PUR-1401 ADDENDUM NO. 6 INVITATION TO BID

WASHINGTON COUNTY PUBLIC SAFETY TRAINING CENTER

DATE: Monday, September 14, 2020

ALUMINUM STOREFRONT ELEVATIONS

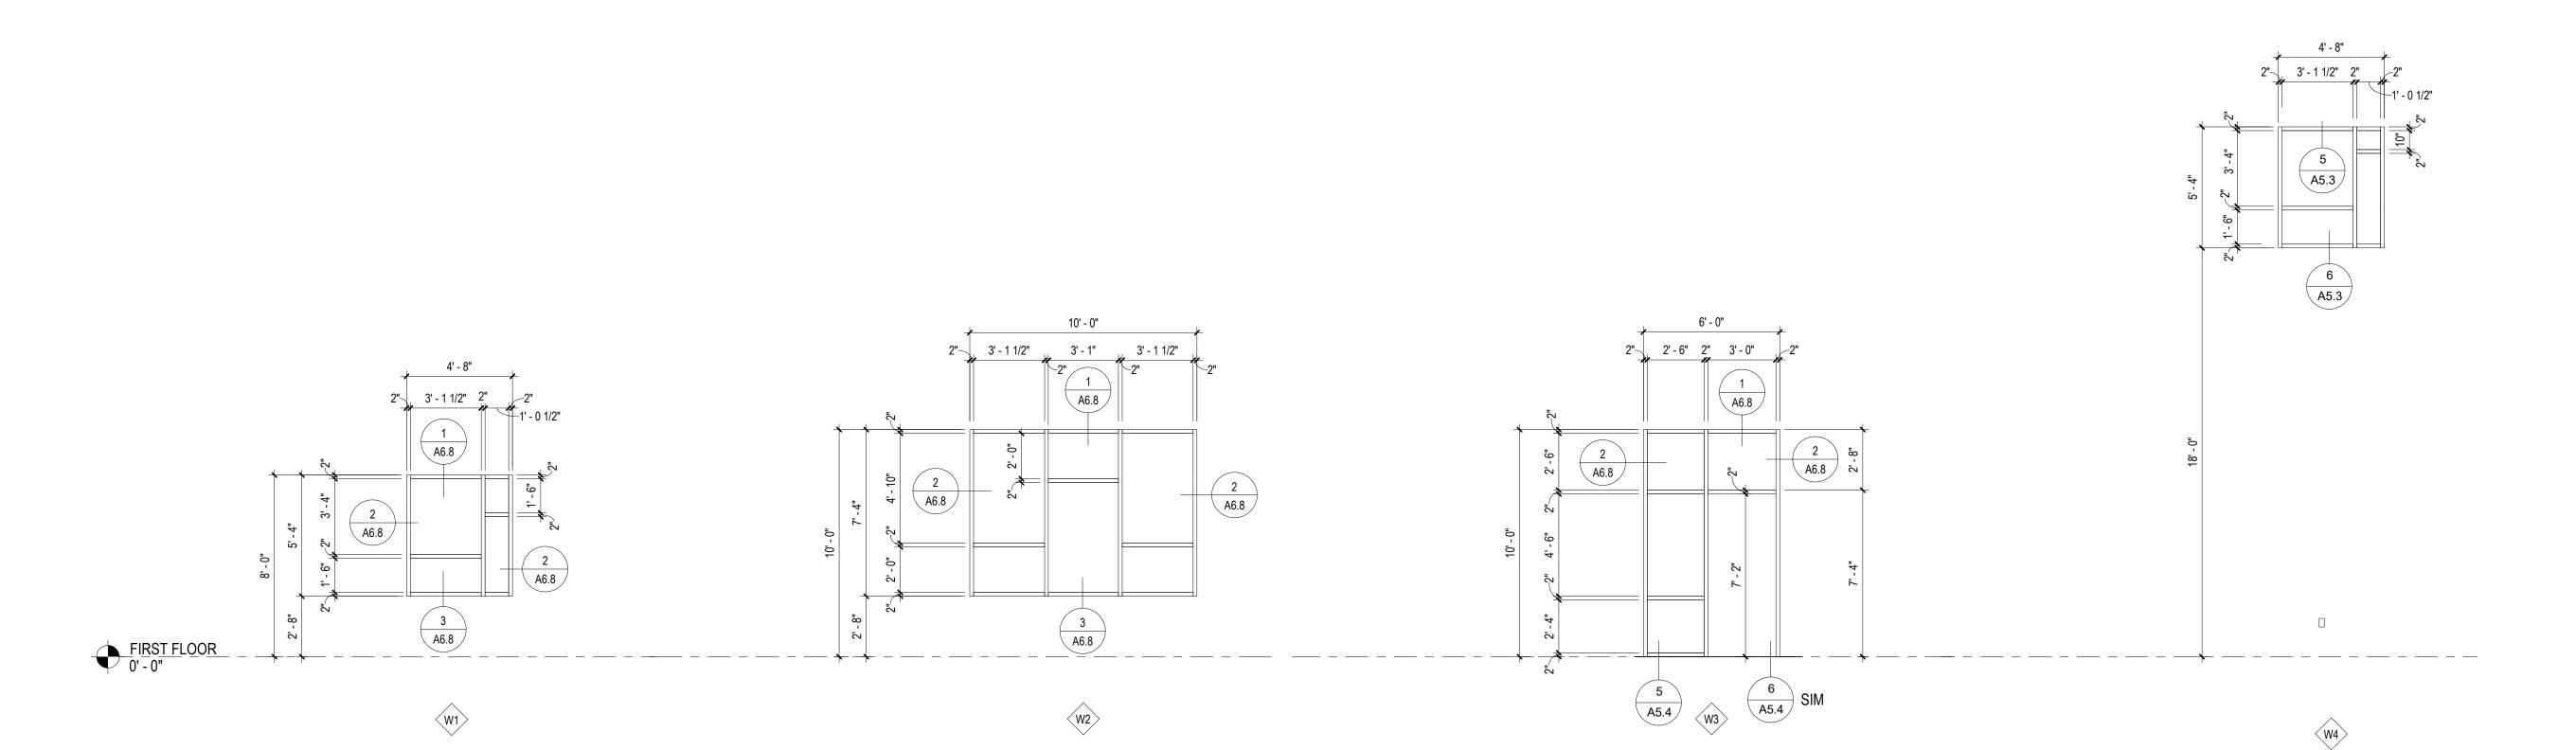
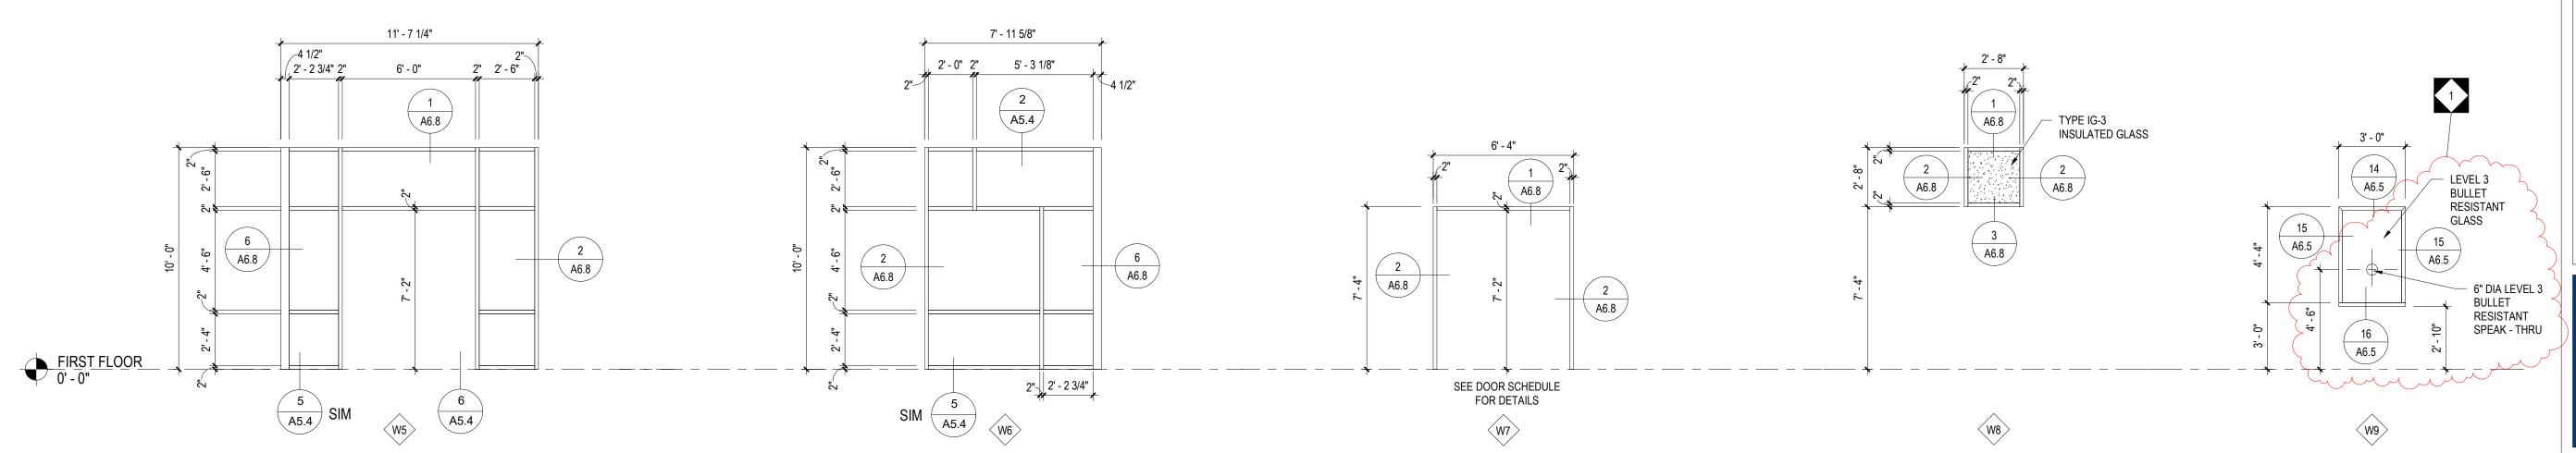
- Refer to Drawing A6.6, Aluminum Storefront Elevations, Elevation W9; **CHANGE**, glazing to read "LEVEL 3 BULLET RESISTANT GLASS" and **ADD** 6" round Level 3 Bullet Resistant Speak-Thru at 4'-6" AFF. See attached revised drawing (Attachment E).

TYICAL WALL DETAIL AT CEMENT BOARD SIDING

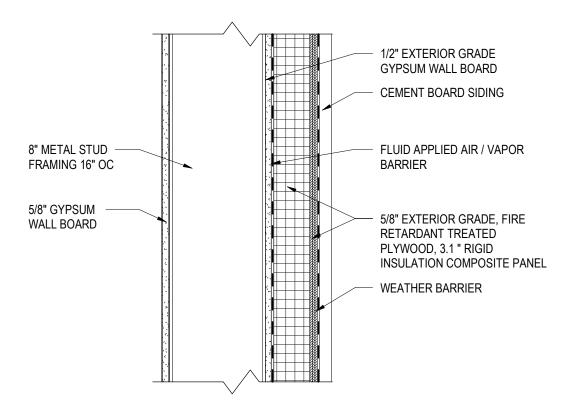
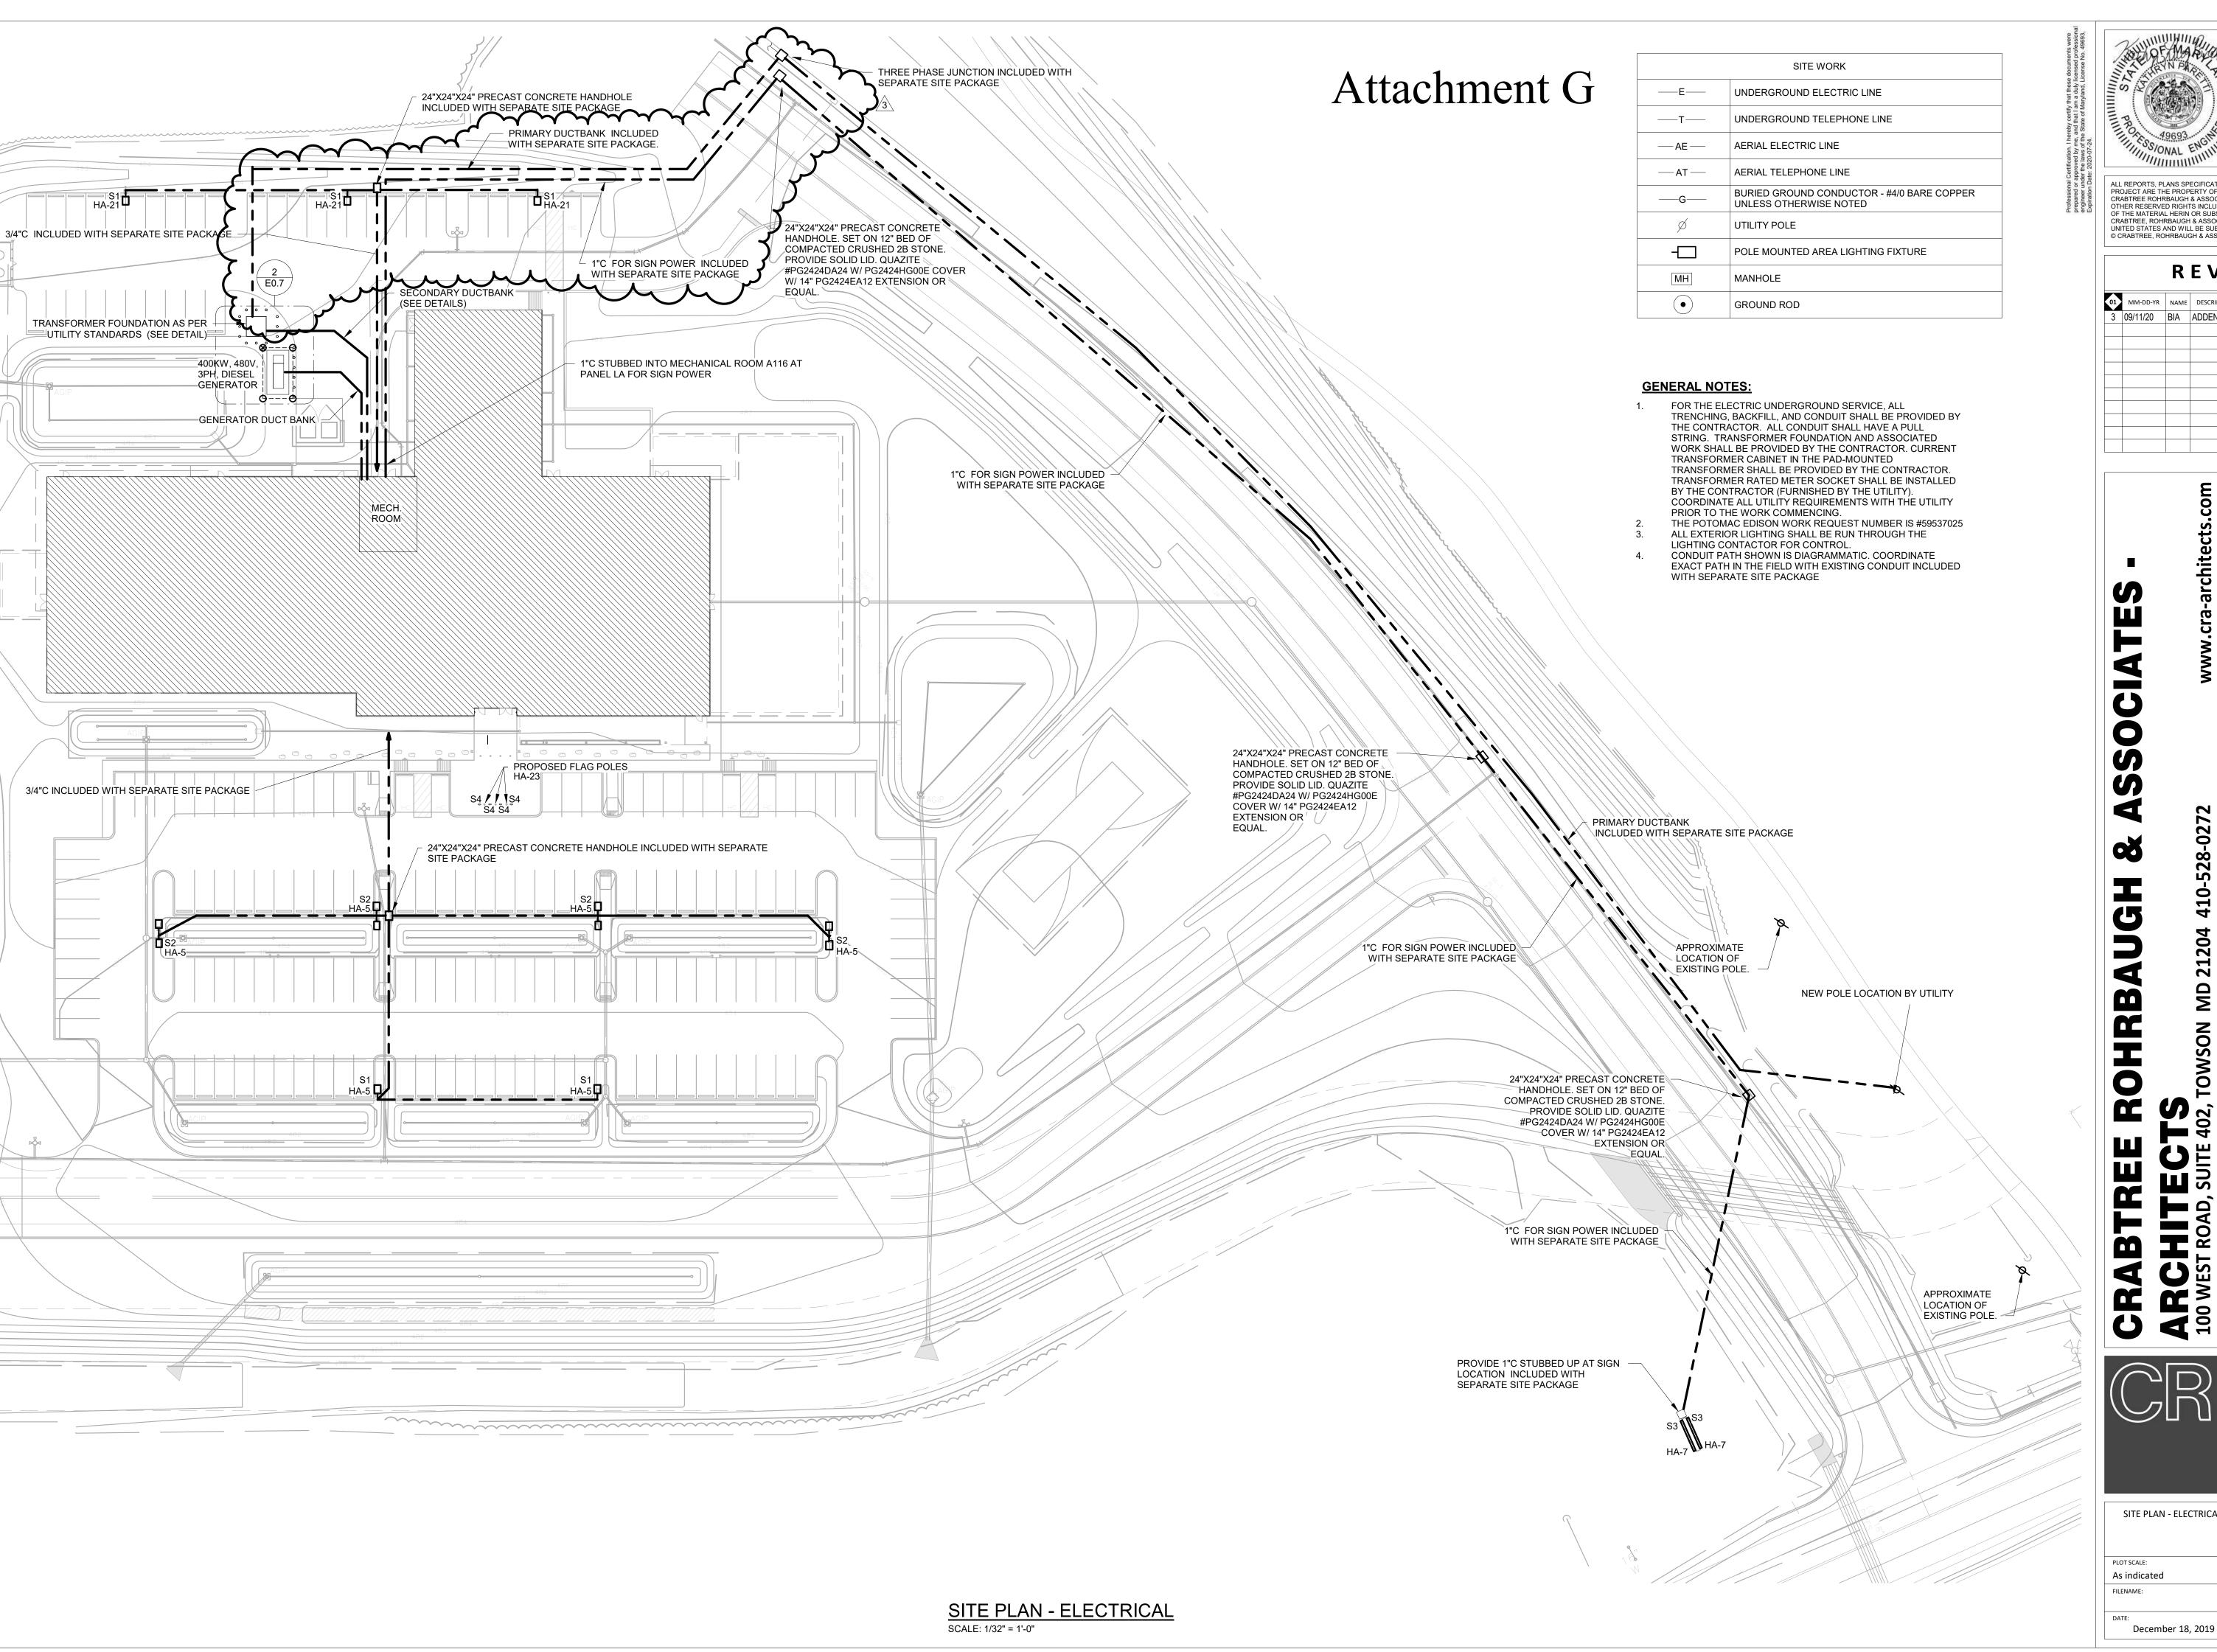
- ITEM NO. 30: Refer to Wall Section Sheets A3.5, A3.7, A3.8, A3.9, A3.10, A3.12, A3.13, A3.14 and Detail Sheets A5.2, A5.3, A5.4, A5.5 and A6.10, at upper exterior walls of Secure Vestibule A100, Corridor A119 and Multi-Purpose C100 where 8" metal stud walls with cement board siding are indicated; CHANGE, exterior wall type to match attached revised wall type (Attachment F).
